RB2-13

R102.7.1

Proposed Change as Submitted

Proponent: David Bonowitz, Chair, Existing Buildings Subcommittee, Code Advisory Committee, representing National Council of Structural Engineers Associations (dbonowitz@att.net)

**FIGURE R301.2(4)A
ULTIMATE DESIGN WIND SPEEDS**

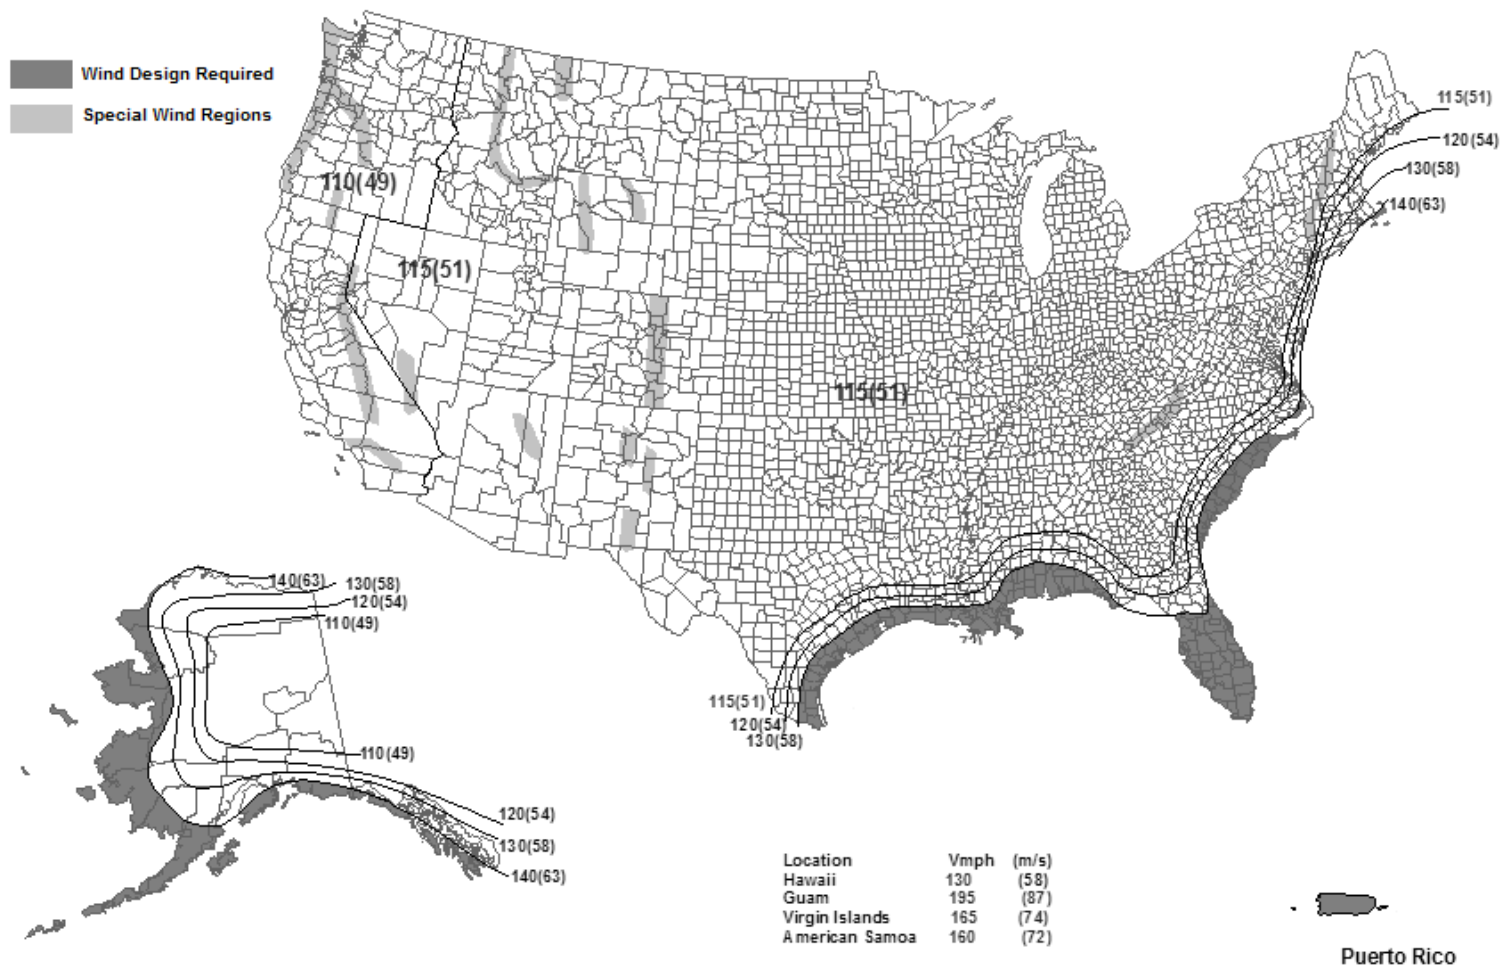
R301.2.1 Wind design criteria. Buildings and portions thereof shall be constructed in accordance with the wind provisions of this code using the ultimate design ~~basic~~ wind speed in Table R301.2(1) as determined from Figure R301.2(4)A. The structural provisions of this code for wind loads are not permitted where wind design is required as specified in Section R301.2.1.1. Where different construction methods and structural materials are used for various portions of a building, the applicable requirements of this section for each portion shall apply. Where not otherwise specified, the wind loads listed in Table R301.2(2) adjusted for height and exposure using Table R301.2(3) shall be used to determine design load performance requirements for wall coverings, curtain walls, roof coverings, exterior windows, skylights, garage doors and exterior doors. Asphalt shingles shall be designed for wind speeds in accordance with Section R905.2.4. A continuous load path shall be provided to transmit the applicable uplift forces in Section R802.11.1 from the roof assembly to the foundation.

R301.2.1.3 Wind speed conversion. When referenced documents are based on nominal design-fastest mile wind speeds, the ultimate design-three-second gust basic wind speeds, $V_{ult}-V_{3s}$, of Figure R301.2(4)A shall be converted to nominal design-fastest mile wind speeds, $V_{asd}-V_{fm}$, using Table R301.2.1.3.

**FIGURE R301.2(7)
COMPONENT AND CLADDING PRESSURE ZONES**

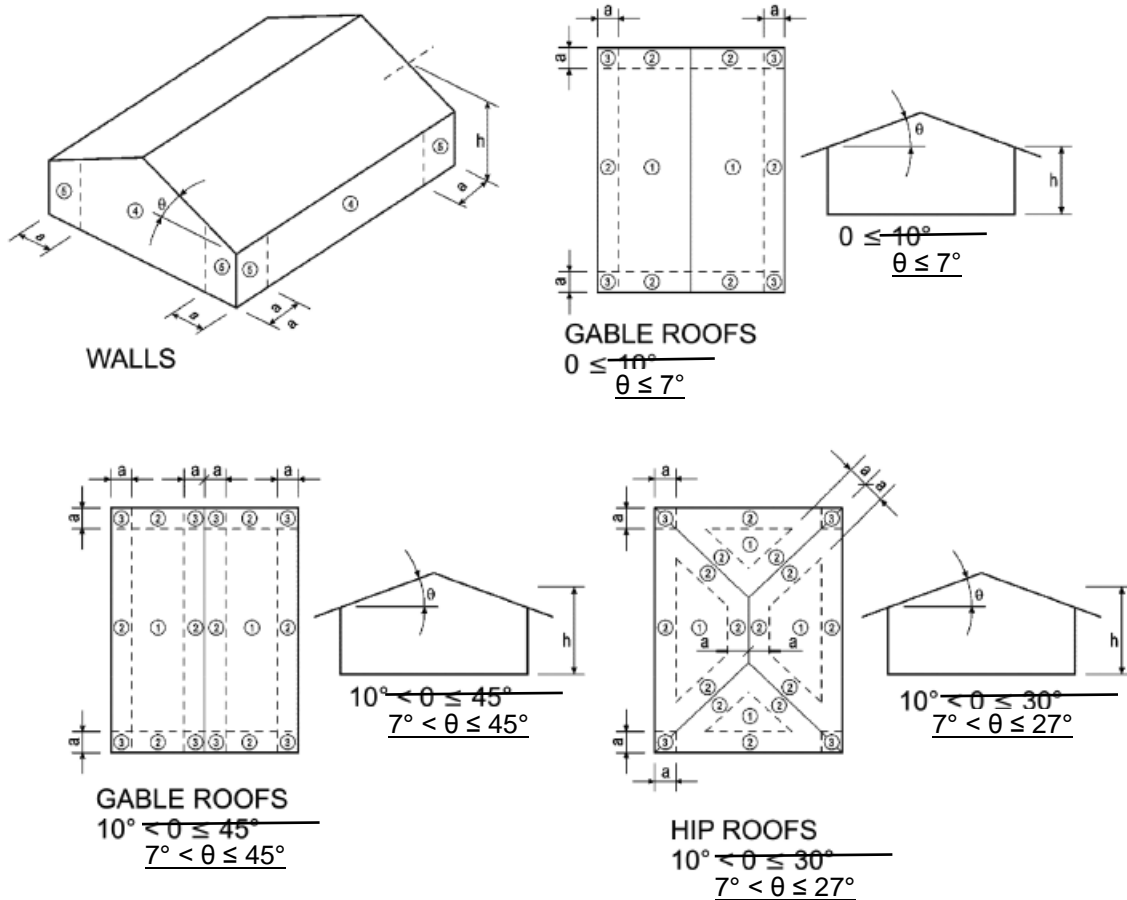
**TABLE R301.2(2)
COMPONENT AND CLADDING LOADS FOR A BUILDING WITH A MEAN ROOF HEIGHT OF 30 FEET LOCATED IN EXPOSURE B (ASD)(psf)^{a, b, c, d, e}**

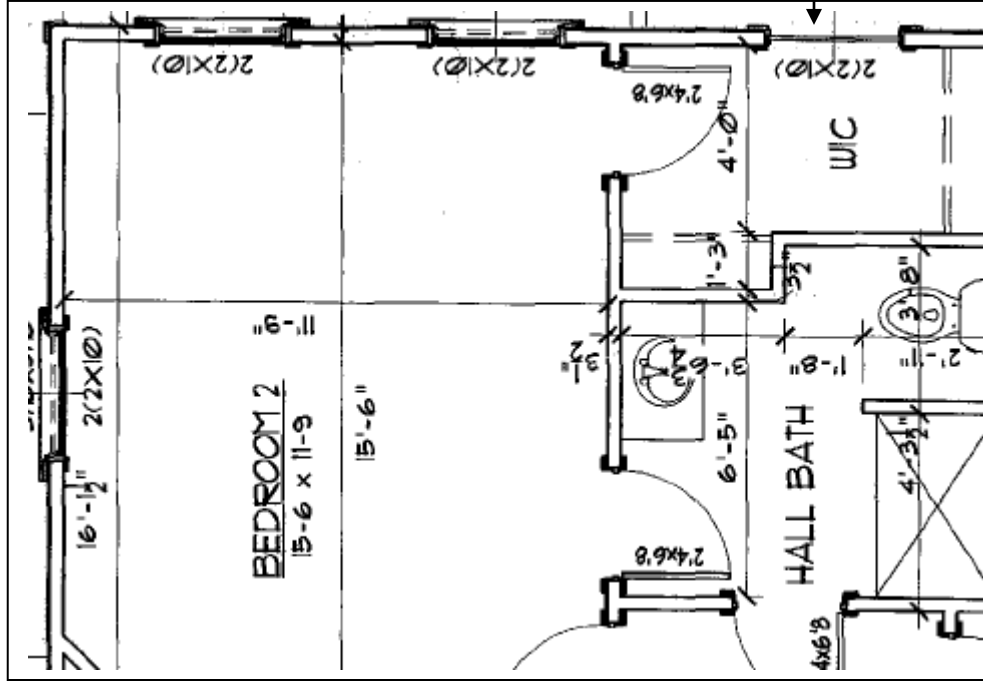
Exception 3: Currently the code requires safety glazing for windows on the hinge side of walls perpendicular to the door plane – regardless of the door swing. See sketch below.

Currently this window is NOT exempt by rule # 3 (or #4) and would have to be safety glazed. If this proposal is accepted, this window would NOT have to be safety glazed.

This window is currently exempt because the arc is more the 24" from the door hinge.

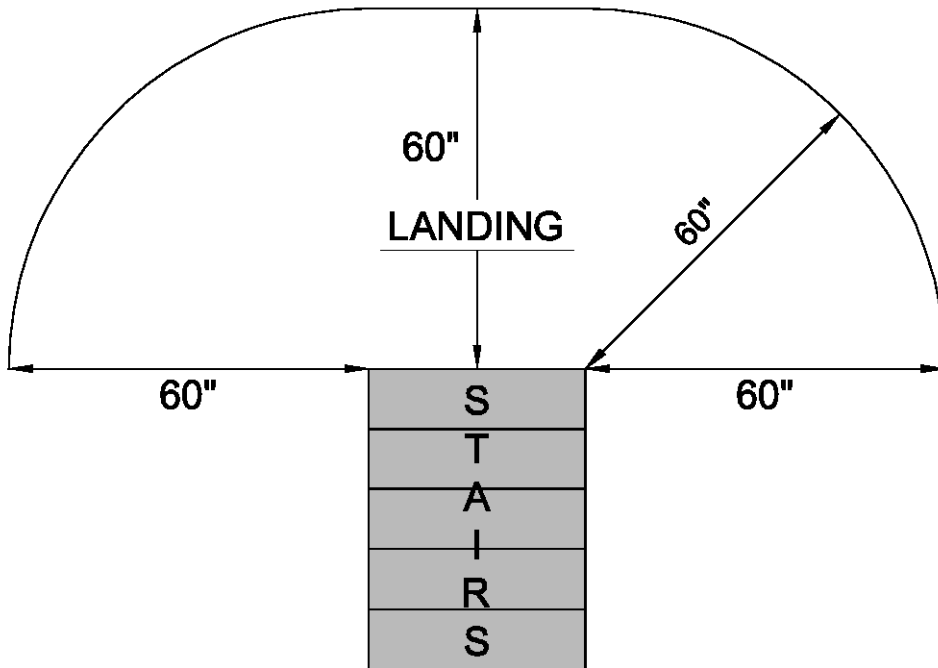
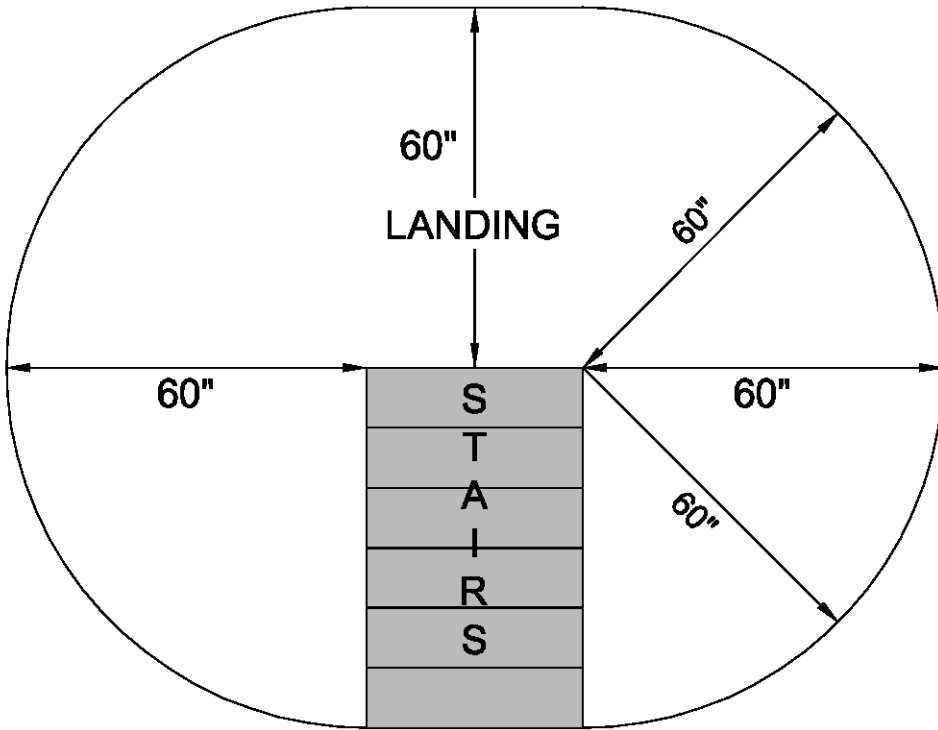
R308.4.7 Glazing adjacent to the bottom stair landing. Glazing adjacent to the landing at the bottom of a stairway where the glazing is less than 36 inches (914 mm) above the landing and within a 60 inches (1524 mm) ~~horizontally of horizontal arc less than 180 degrees from~~ the bottom tread nosing shall be considered a hazardous location.

Exception: The glazing is protected by a guard complying with Section 312 and the plane of the glass is more than 18 inches (457 mm) from the guard.

The new code language will incorporate the areas shown in the following diagram:

The current code language incorporates the area shown below in the diagram:

FIGURE R324.5
FOUNDATION TYPES

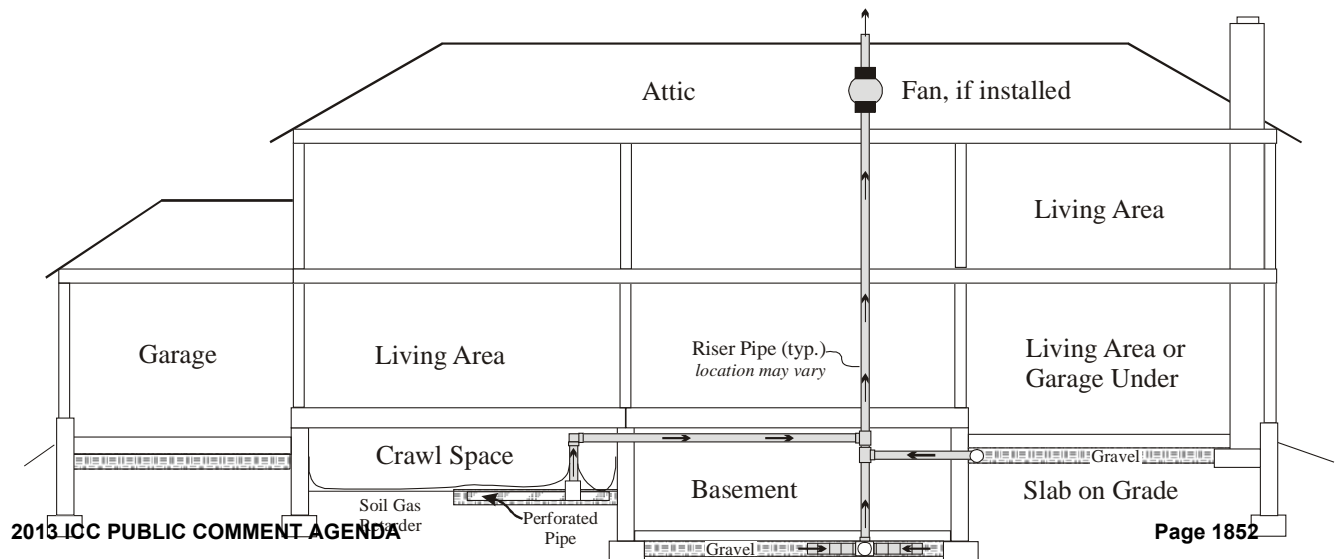
R324.5 Mitigation system rough-in required. The Rough-In installation of a mitigation system shall be required for all foundations and combination foundations types, including crawl space, basement, slab-on-grade and slab-on-grade garage located below a living area. The installation shall be in accordance with Sections R324.6 through R324.28. Figure R324.5 illustrates the four foundation types.

FIGURE R324.42
RADON POTENTIAL ZONES MAP
TABLE R324.42 EPA RADON ZONE 1 and 2 COUNTIES BY STATE

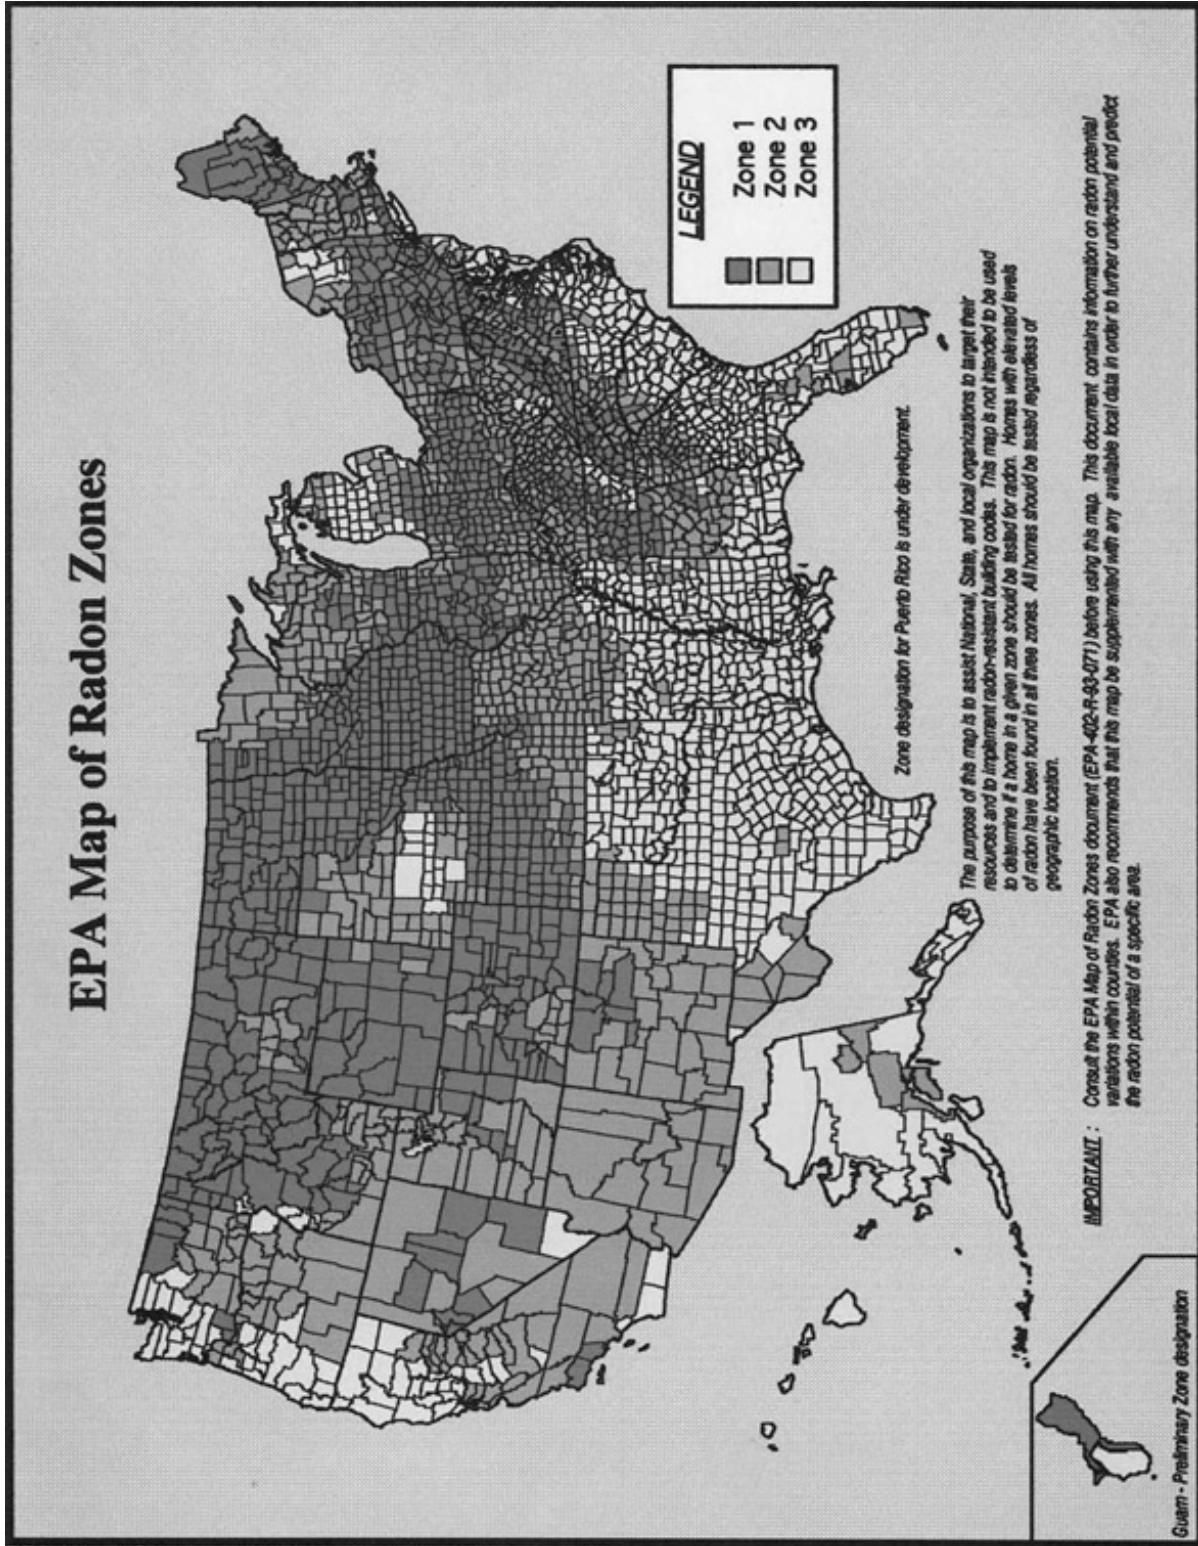
R324.42 EPA established zones. The *radon* potential of a building site shall be estimated from Figure R324.42 or from Table R324.42. Where state or local jurisdictions have published *radon* potential data, such data shall supersede the information in Figure R324.42 and Table R324.42.
